Peer Review of Highlands Neighborhood Traffic and Pedestrian Safety Plan

~~DRAFT~~ **FINAL** REPORT

Prepared for:
Ada County Highway District

Prepared by:
SIX MILE ENGINEERING, PA

Figure 2-5. Estimated cut-through traffic on Lower Braemere Road before mitigation

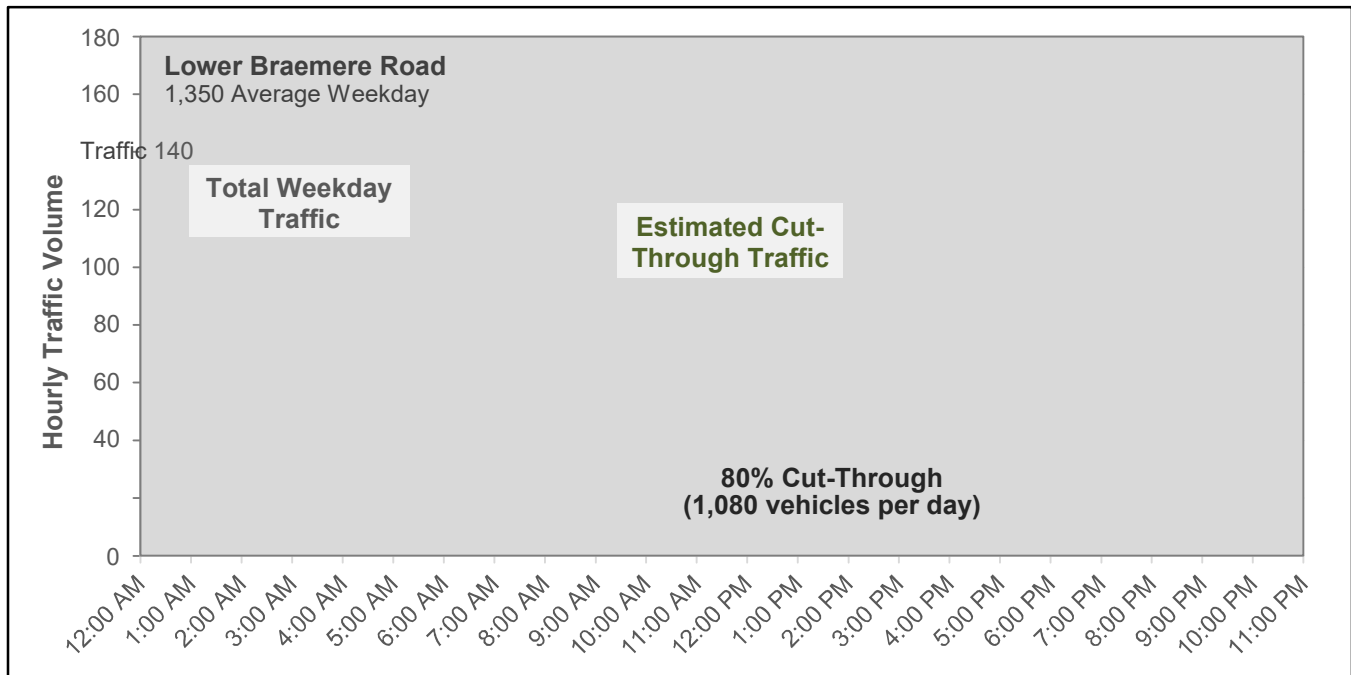
On Lower Braemere Road, the estimated cut-through traffic is ~~shown in Figure 2-5~~shown in Figure 2-5 on page 13. ~~During~~Based on traffic counts, the average weekday, traffic volume on Lower Braemere Road was ~~counted at~~ approximately 1,350 vpd. At the count location, approximately, 270 vpd are estimated to be non-cut-through trips, resulting in the estimated cut-through traffic of approximately 1,080 vpd, or 80 percent of the daily traffic.
